PLAT REVIEW

Name of Proposed Subdivision Harbor Landing Revised Phase I
Location of Proposed Subdivision Chandlers Landing
Name of Subdivider Rockwall South Joint Venture
Date Submitted March 11, 1986 Date of Review 3-25-86
Total Acreage 9.7 Number of Lots 38

HAROLD L. EVANS CONSULTING ENGINEER 2331 GUS THOMASSON RD. SUITE 102 DALLAS, TEXAS 75228 PHONE (214) 328-8133			REVISED PRELIMINARY PLAT HARBOR LANDING CITY OF ROCKWALL, ROCKWALL COUNTY, TEXAS		
SCALE	DATE	JOB NO.	ROCKWALL SOUTH JOINT VENTURE OWNER P.O. BOX 1234 GREENVILLE, TEXAS PH. 455-3082		
1" = 60'	3-10-86	84186

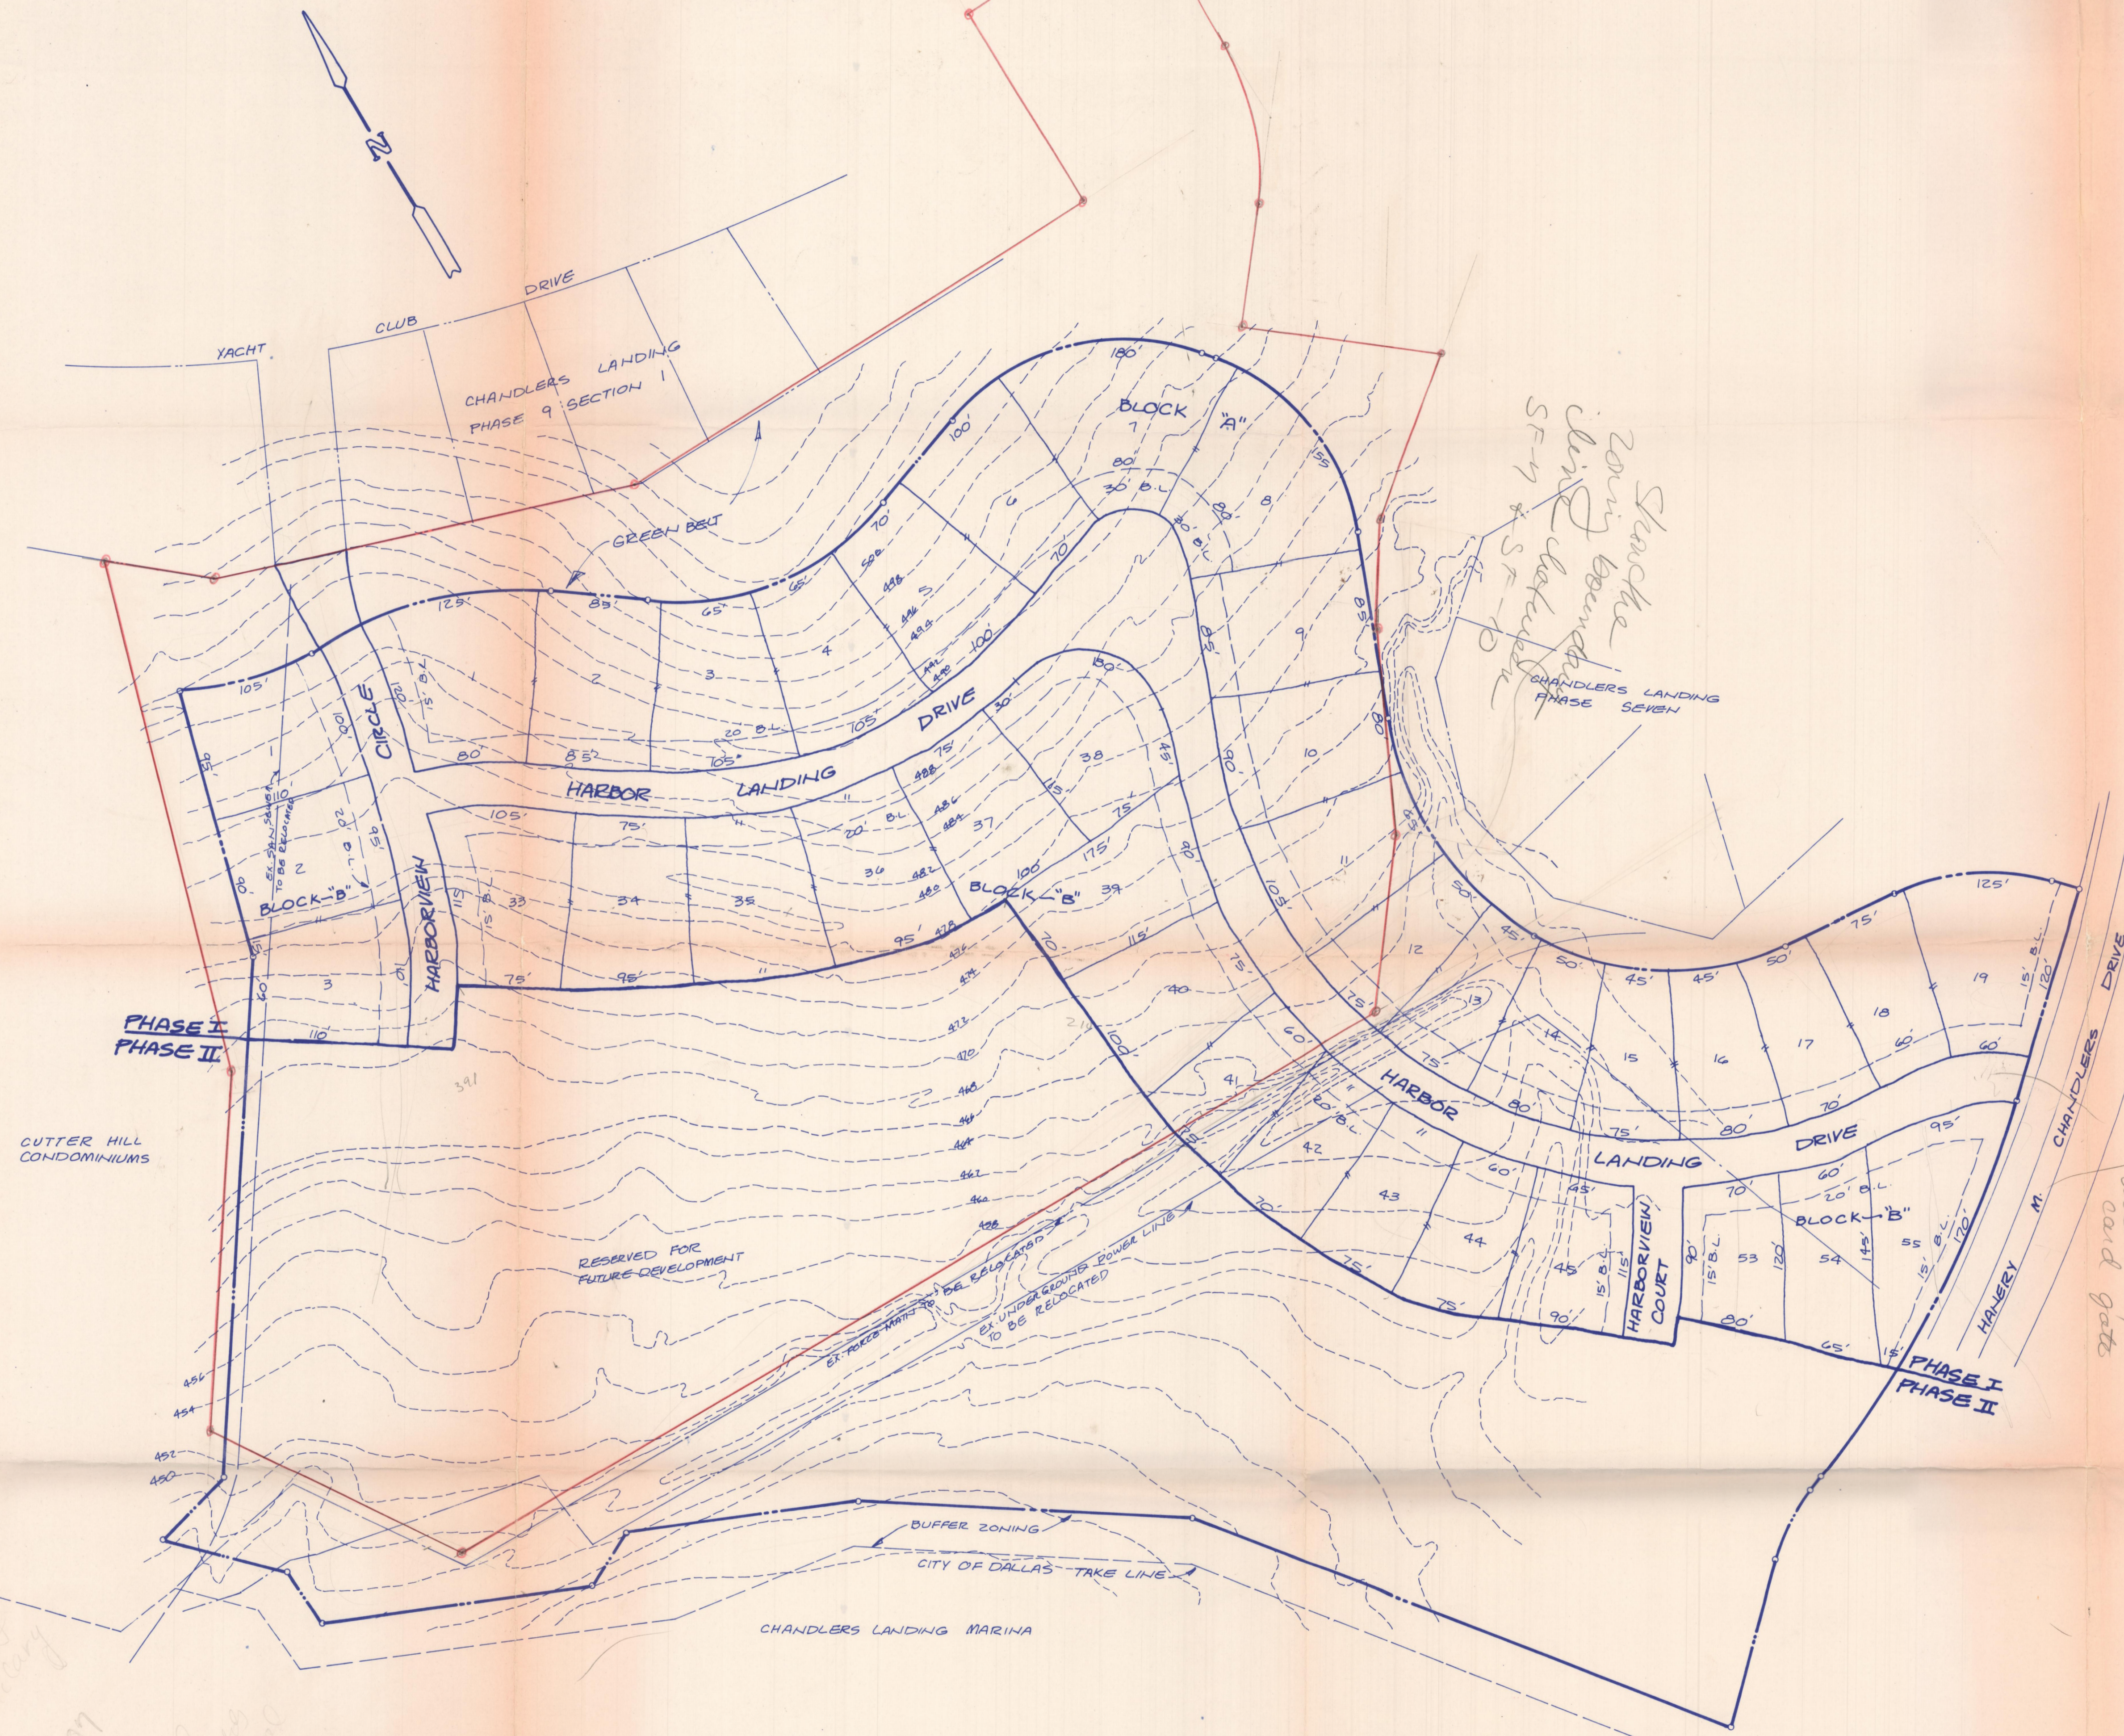
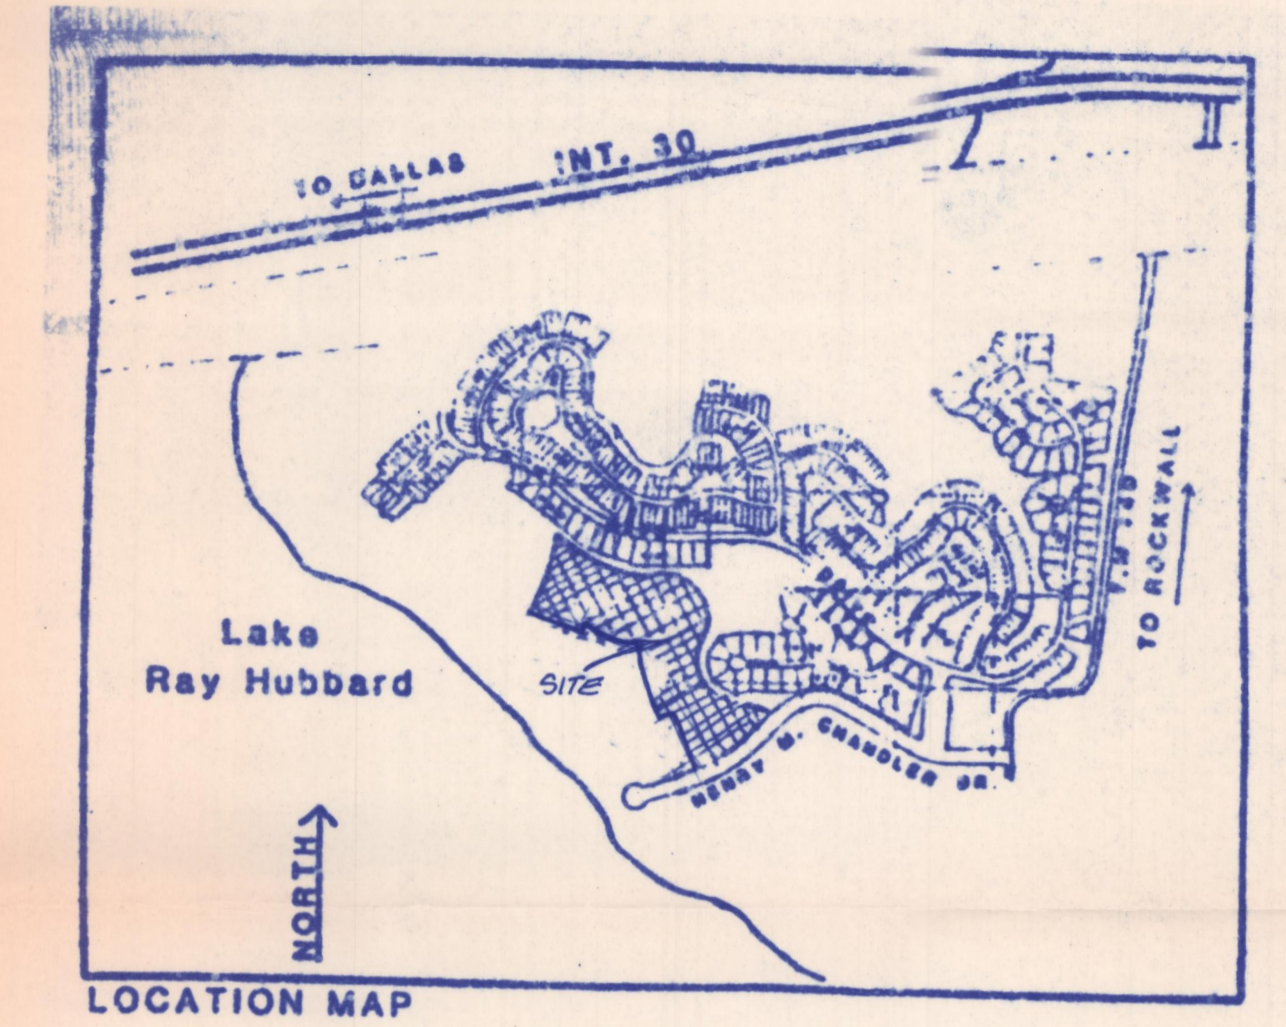
*Shackle
Zoning boundary
line located
SF-7 & SF-10*

*unchanged
areas w/
and gate*

*Shackles
Marked on map
2/2/86
847-9907
151-0160
Play beyond
Harbor Landing
City of Rockwall
9/1/86*

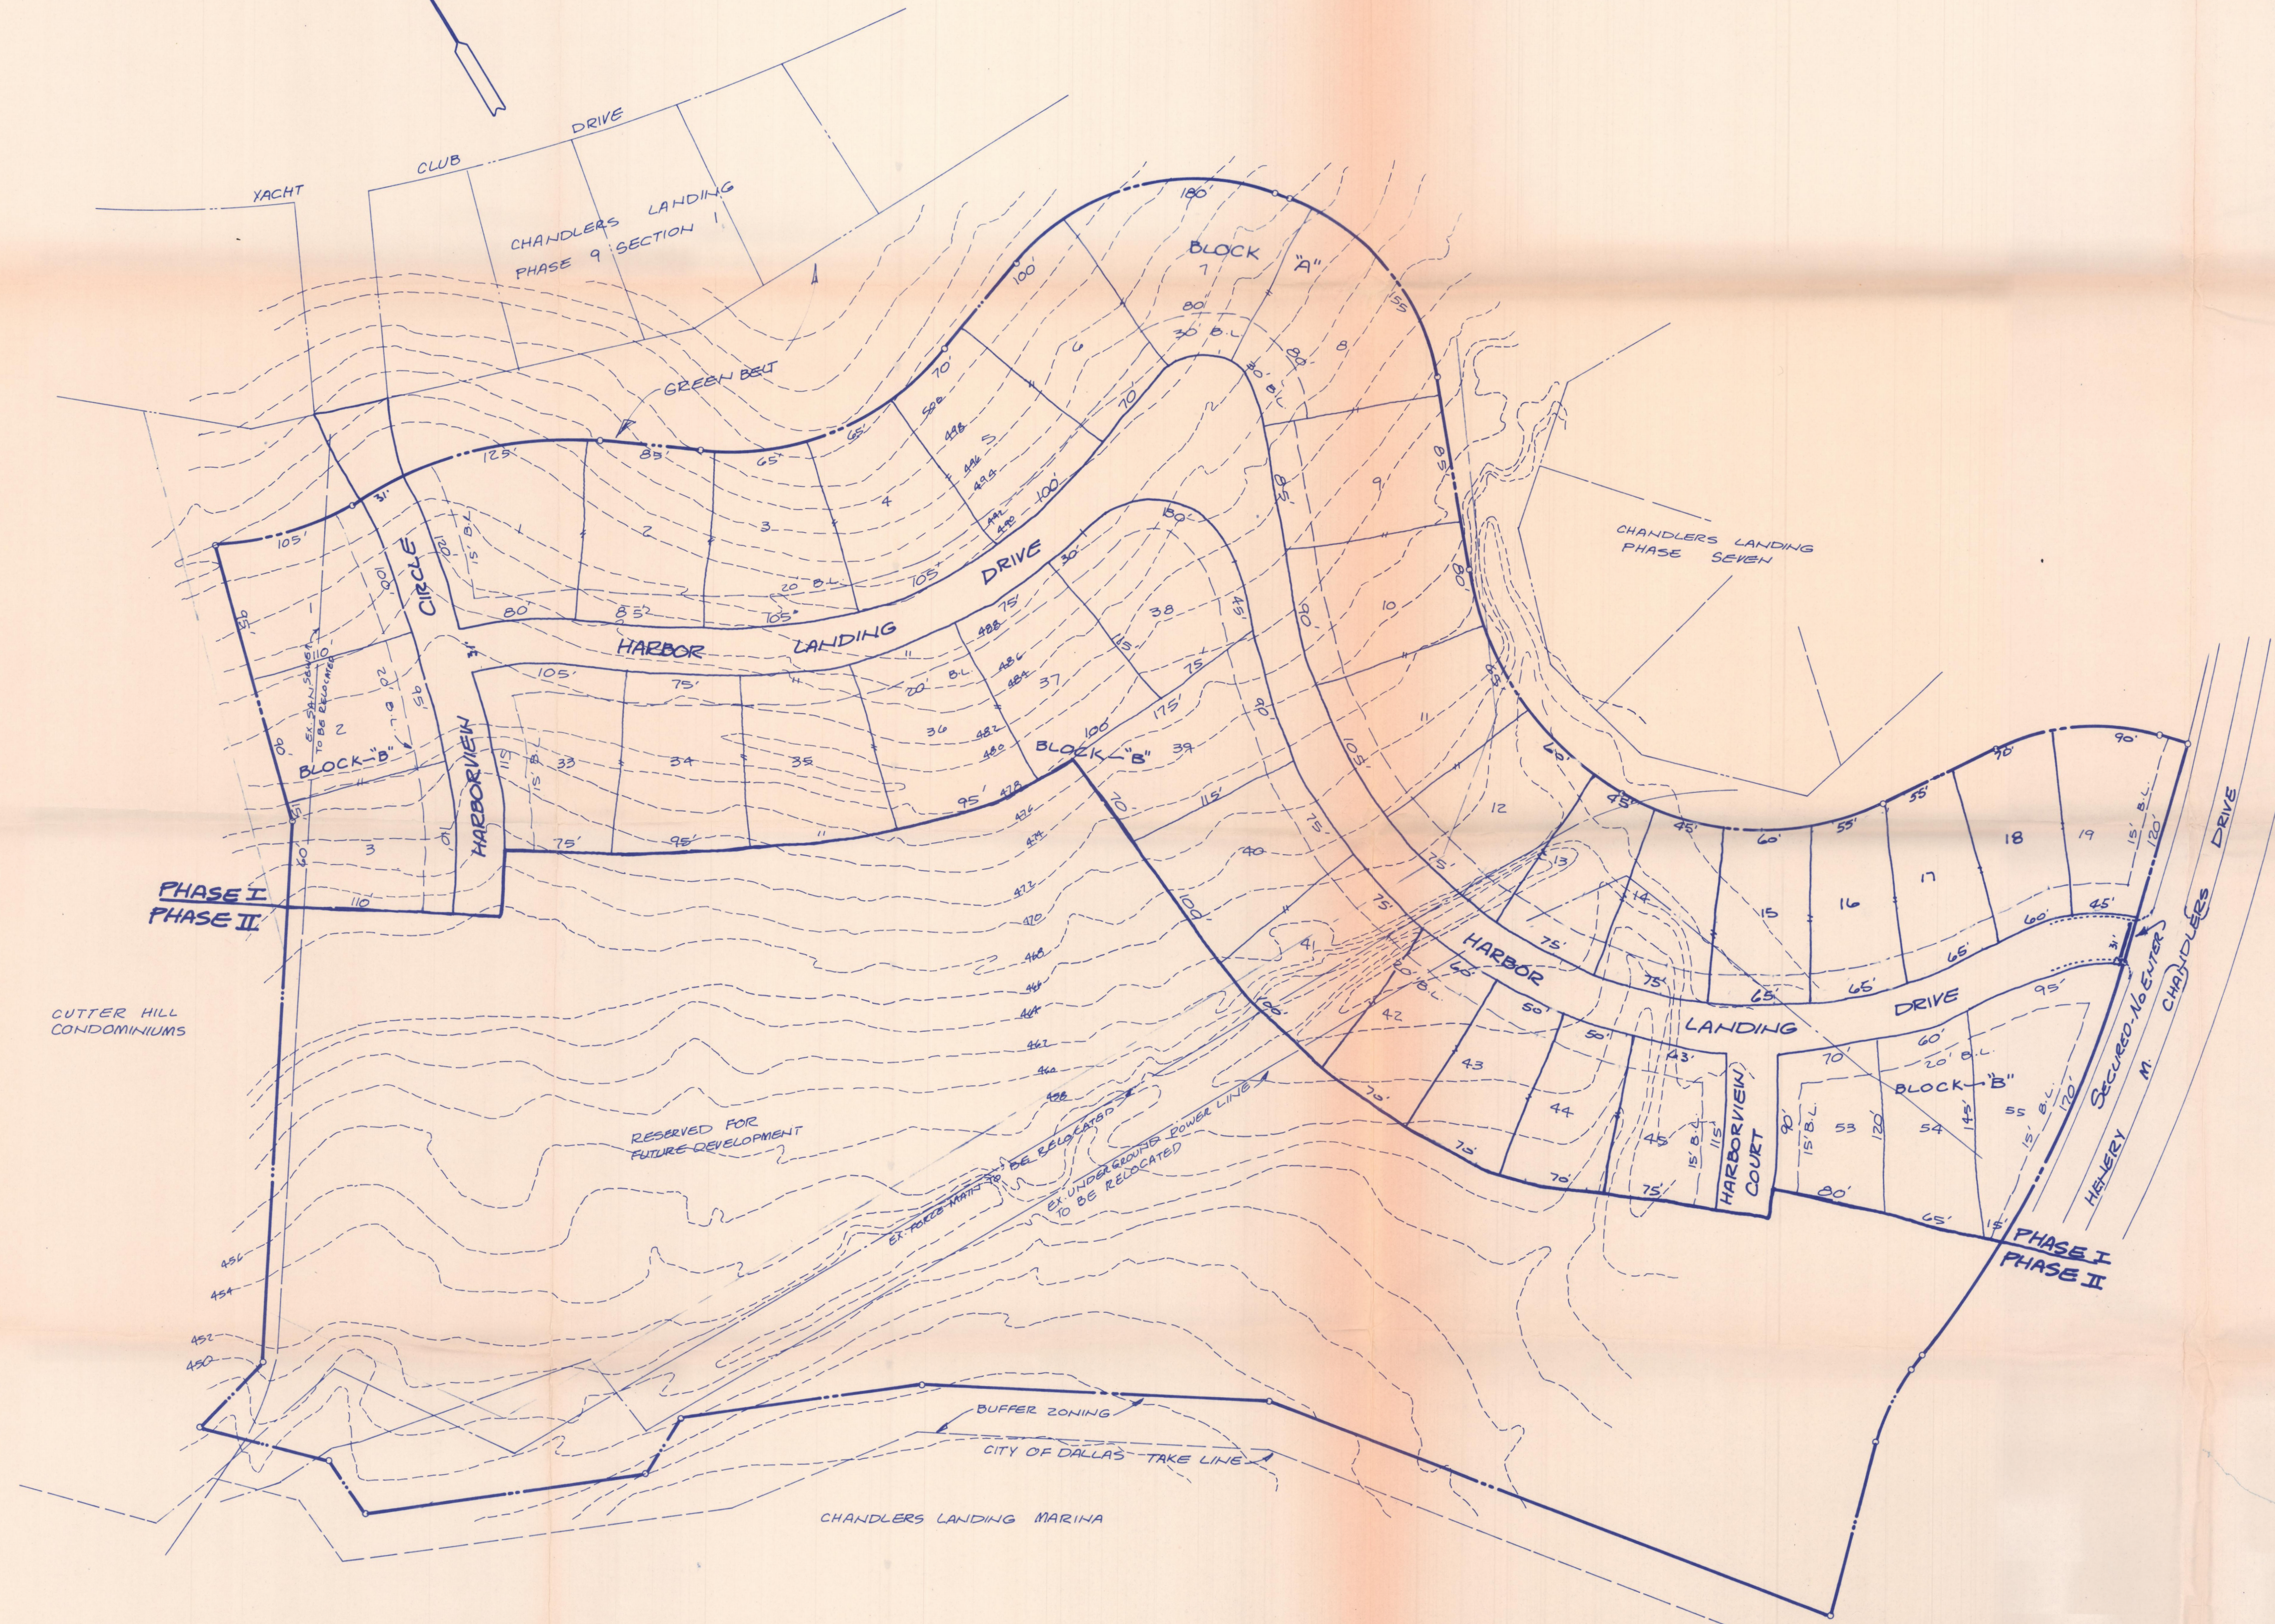
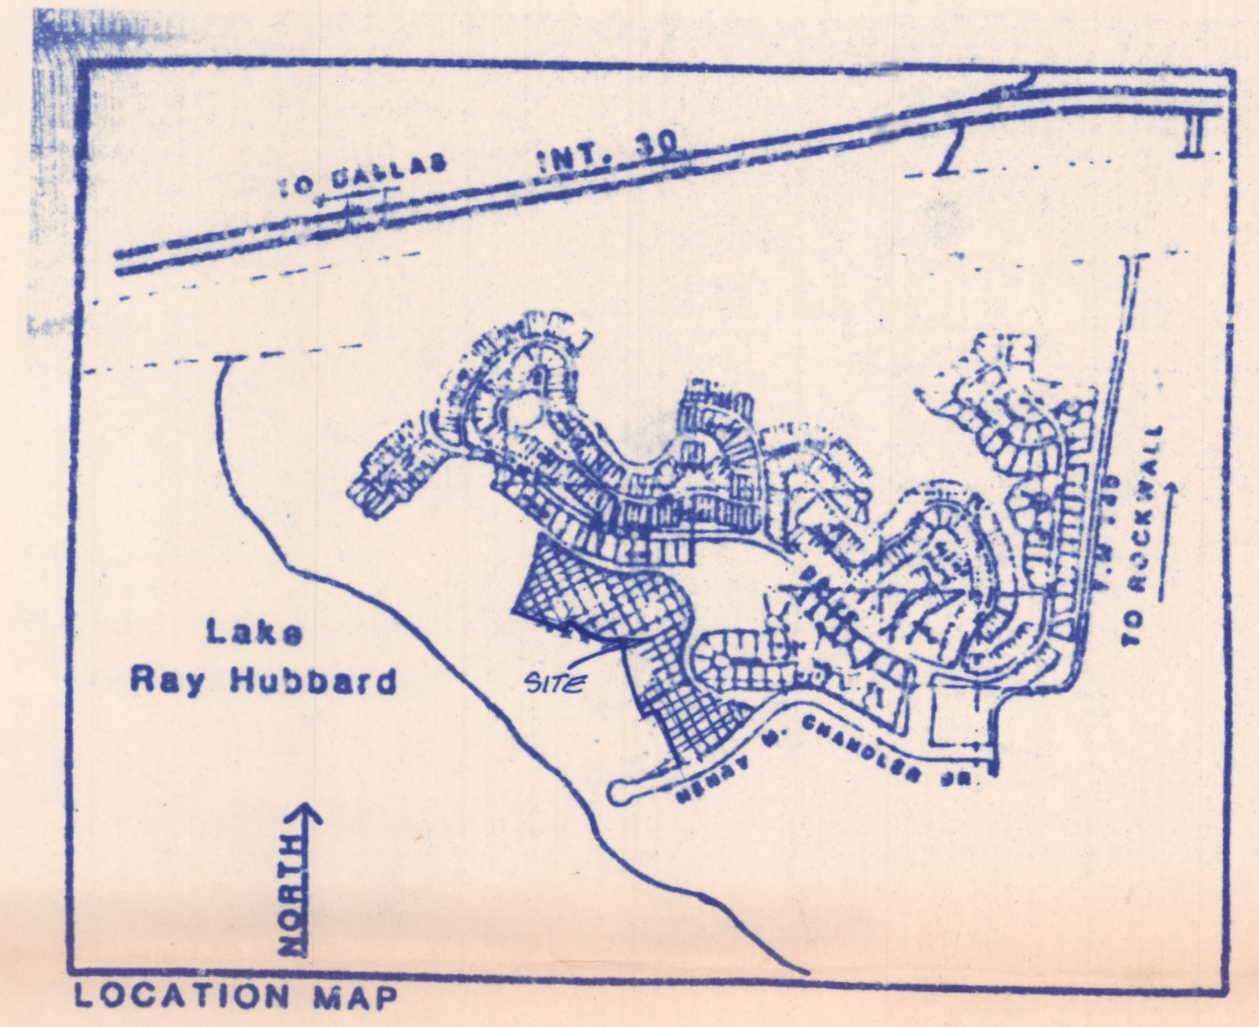
REV. 4-9-86: LOT 1, 2, 41, 75, 81, 82
